Central Zoo Authority

F. No. 19-256/93-CZA(193)(Vol. III)(M)/2050

Sub:- Construction of enclosures at Nagaland Zoological Park, Rangapahar.

The designs for the construction of enclosures for Great Indian hornbill, Barking deer, Hoolock gibbon, Fox, Common leopard, Stump tailed macaque, Burmese tortoise, Jungle cat and 2.5 km metalled by pass road at Nagaland Zoological Park, Rangapahar were placed before the Meeting of the Expert Group on Zoo Designing of the Central Zoo Authority held on 12th December, 2011. The observations of the committee are given below:-

(STUMP TAIL MACRAQUE ENCLOSURE)

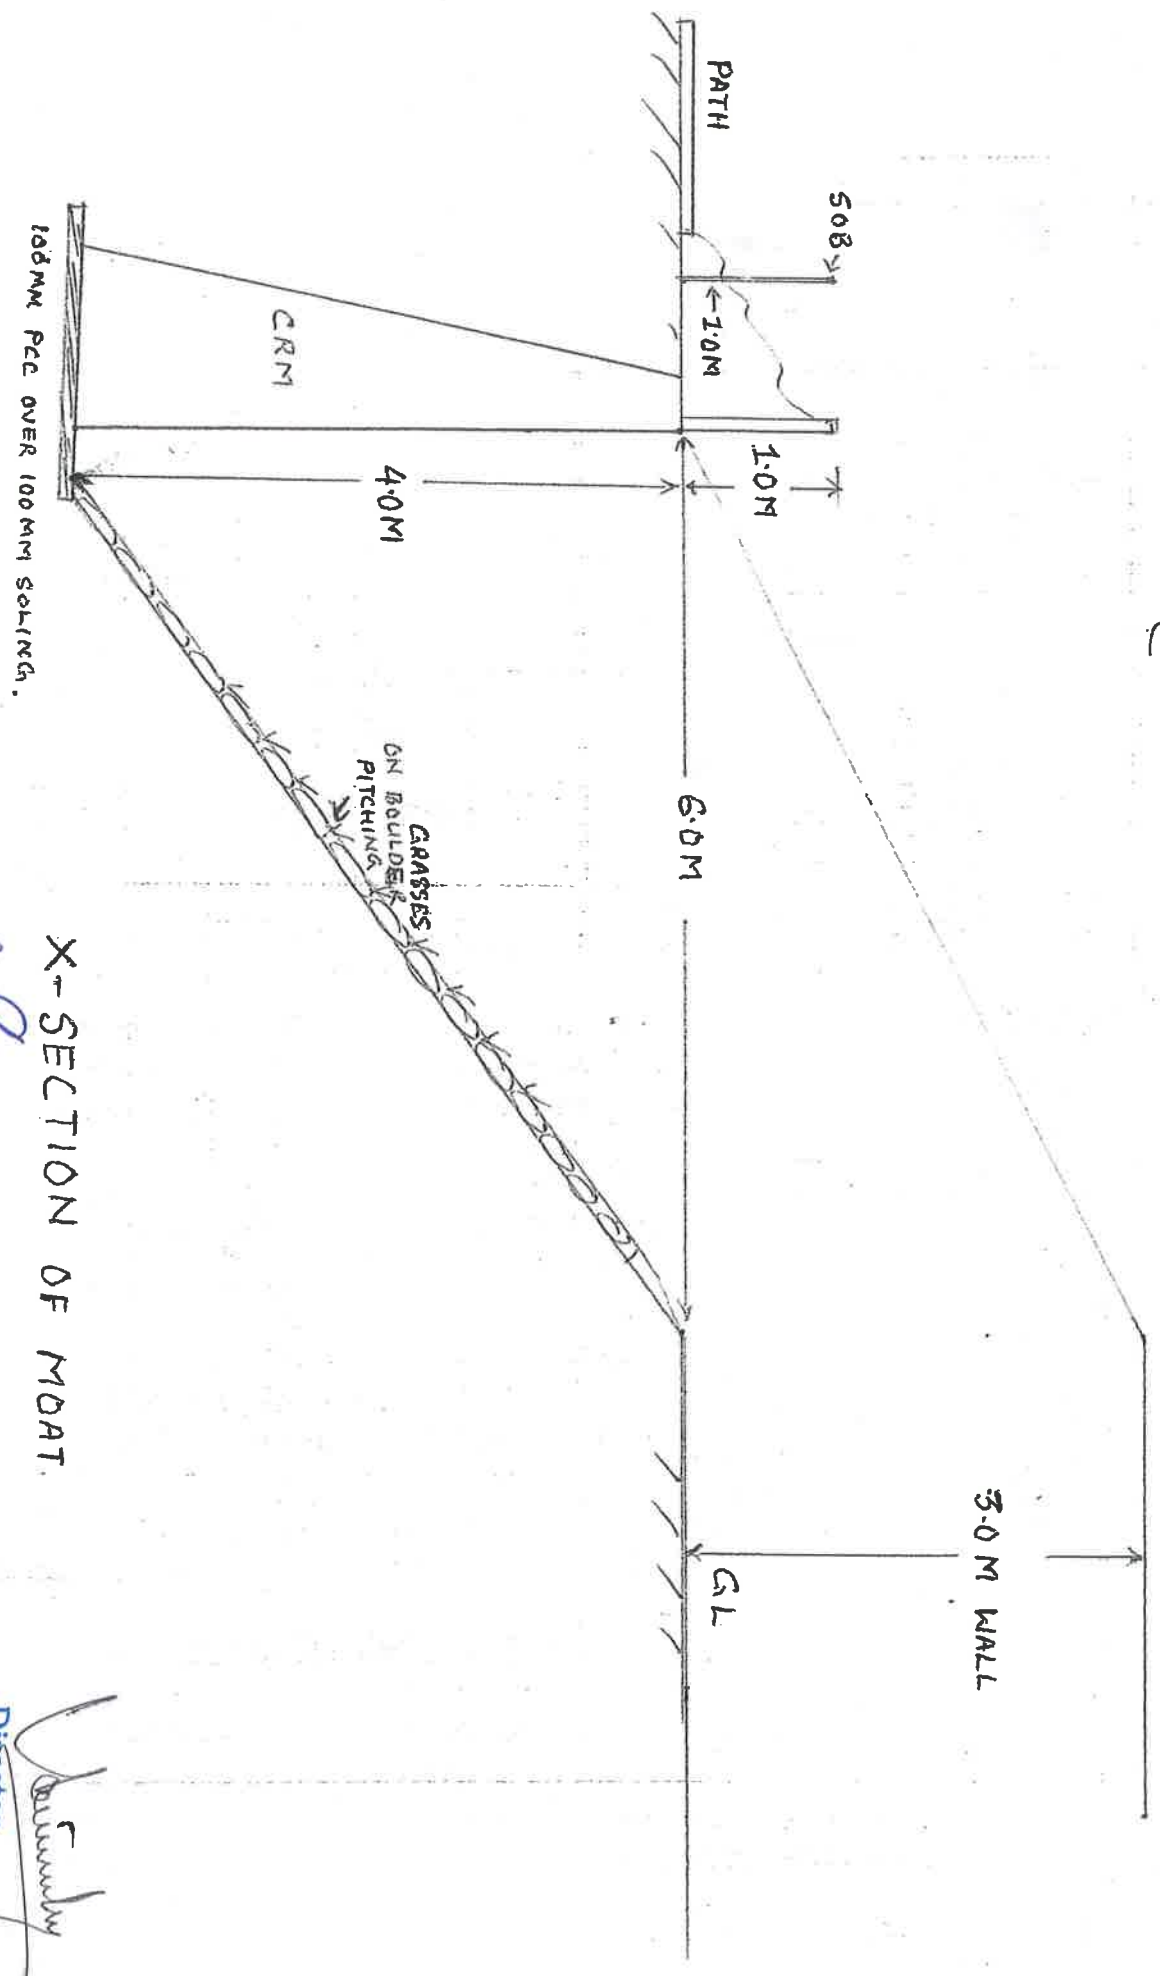
- (a) No cement and concrete should be used in paddock area to construct mounds etc.
- (b) The kraal should be increased in size.
- (c) There should be no swing door in the feeding retiring cells towards keepers gallery.
- (d) All the feeding retiring cells (except the middle one) should have fixed iron bares instead of using chain-link mesh of an appropriate size and thickness. The feeding and retiring cells located in the middle should have a drop slide in front and sliding door on both the sides.
